REGION OF PEEL
WASTEWATER CAPACITY IMPROVEMENTS IN CENTRAL MISSISSAUGA
APPENDIX 1-E

Public Information Centre No. 2

Wastewater Capacity Improvements in Central
Mississauga

Public Information Centre No. 2 – Summary Report

Sherway Drive Shaft Compound

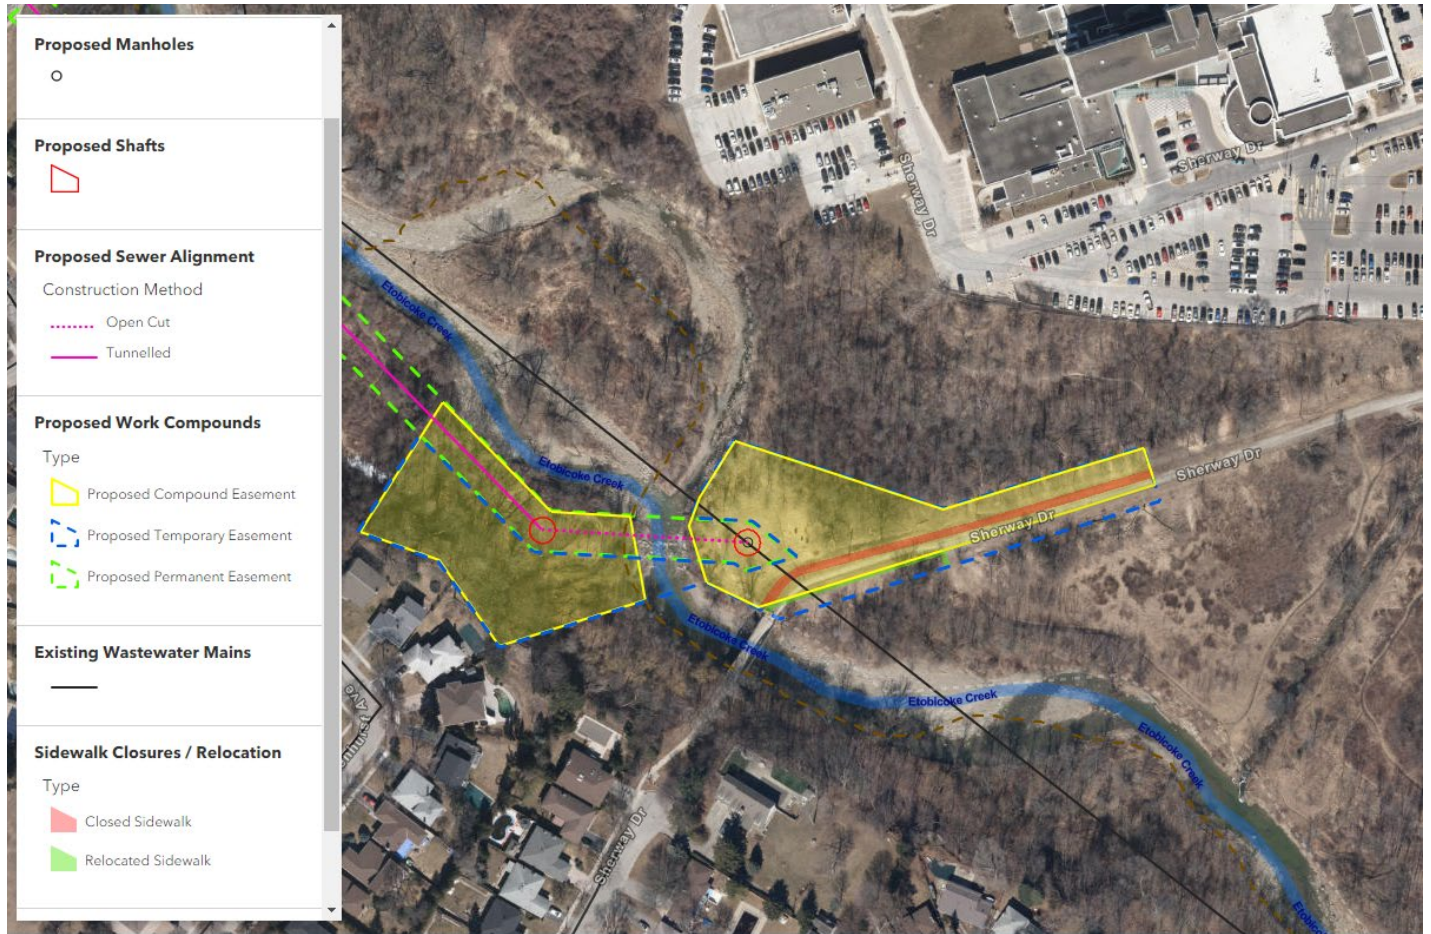
| ITEM | TRCA COMMENT (May 26, 2021) | PROPONENT/CONSULTANT RESPONSE (July 26, 2021) |
|------|--|---|
| 1. | Please provide analysis of the long -term natural heritage impacts to both 1D and 1B. This analysis is requested to support review of the TRCA’s avoid, minimize, mitigate, and compensate decision making framework. | The Region will complete a natural environment impact assessment report on the preferred design concept for the Project, which will include an assessment of Project effects at Site 1B. The natural environment impact assessment will characterize the existing (baseline) natural environment present within and adjacent to proposed areas of disturbance from the Project and will include an assessment of effects from the Project on the existing natural environment, as well as recommendations for mitigation measures to avoid, minimize and, if required, compensate for effects of the Project on the existing natural environment. |
| 2. | TRCA staff note concerns with the feasibility of constructing the sewer connection at 1B (preferred site) including proposed construction methodologies). Due the to the nature of the study area (large watercourse with high flow volumes, large watercourse span, and potential flashy nature) please provide further information related to management of the construction area. | The Class EA has reviewed and undertaken supporting studies to determine that construction at the preferred site is viable and that there are temporary and permanent mitigation measures that can be used to support construction and post construction management. The Region is committed to working with TRCA during the detailed design and permitting and approvals steps to select and agree mitigation measures, remediation and operations. |
| 3. | The Region has identified that “scour and erosion protection measures are recommended for construction at Site 1B/1D including bank armoring, stream bed armoring, floodplain trench armoring, high flow weirs”. Please provide further information on the analysis or discussion on the feasibility of these measures protecting the proposed infrastructure given the watercourse size and velocity and given that 2 sewer pipes will likely require | The Region completed a Hydraulic and Geomorphic Hazard Assessment at the proposed new sewer and existing sewer location near Etobicoke Creek. The objective of this study was to identify the minimum burial depth and setback limits at the channel, and, in turn, to inform the feasibility and general design concept of implementing one or more options to protect both the proposed infrastructure and current infrastructure (at the point of connection) from future exposure. The study outlined what was considered viable mitigation options to mitigate risk of exposure including bank |

| ITEM | TRCA COMMENT (May 26, 2021) | PROPONENT/CONSULTANT RESPONSE (July 26, 2021) |
|------|---|---|
| 4. | Please provide further information on how the infrastructure will be monitored, and the risk assessment of exposure and the subsequent emergency methods of protection. | Additional construction and mitigation measure methodology will be selected during detailed design. |

Thank you for providing your feedback. The Region acknowledges TRCA's concerns at Shaft 1B. During the Pre-PIC No. 2 consultation meeting on June 1, 2021, GM BluePlan and the Region provided additional measures to minimize construction and long-term impacts at this location:
